Contract #: 04-0120E4
 Cty SF Rte 80 PM.13.4, 13.8
 File # 13.25B

QUALITY ASSURANCE - NONCONFORMANCE REPORT

NCR #28

KFM SUBMITTAL 510-00 – OREGON IRON WORKS (OIW) RESPONSE TO CALTRANS NONCONFORMANCE REPORT (NCR) NO. 028

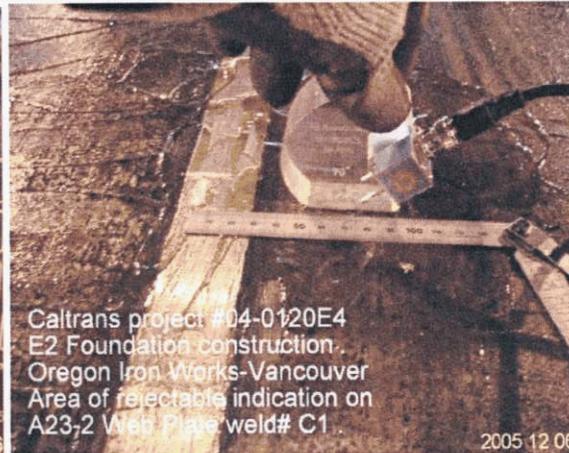
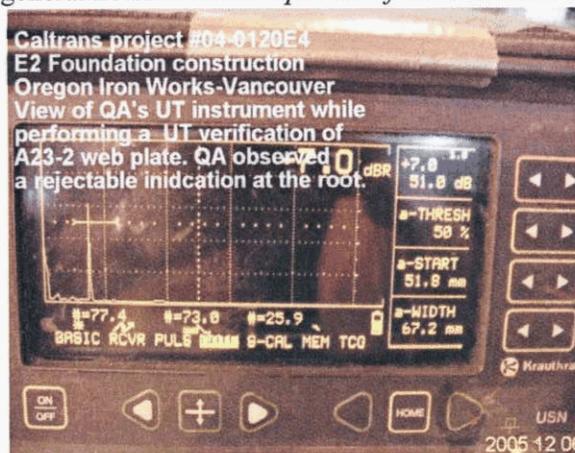
Description of Non-Conformance: Oregon Iron Works Quality Control Inspector Troy Zuercher failed to properly record a rejectable indication on A23-2 web plate weld # C1. Caltrans Quality Assurance Inspector Joe Adame observed a rejectable Class "A" indication during a random verification of a 100% QC inspected weld. The Quality Control Inspector did not take into account the -4 decibel requirement for double groove weld joints as described in Table 6.3 general notes. *Attached pictures from this observation.*

Additionally, the submittal indicates that the areas examined by Mr. Troy Zuercher on piece A23-2, web plate C-1, were reexamined to verify no rejectable defects were missed due to the error. OSM finds the response to NCR 028 to be acceptable and considers the NCR to be resolved at this time.
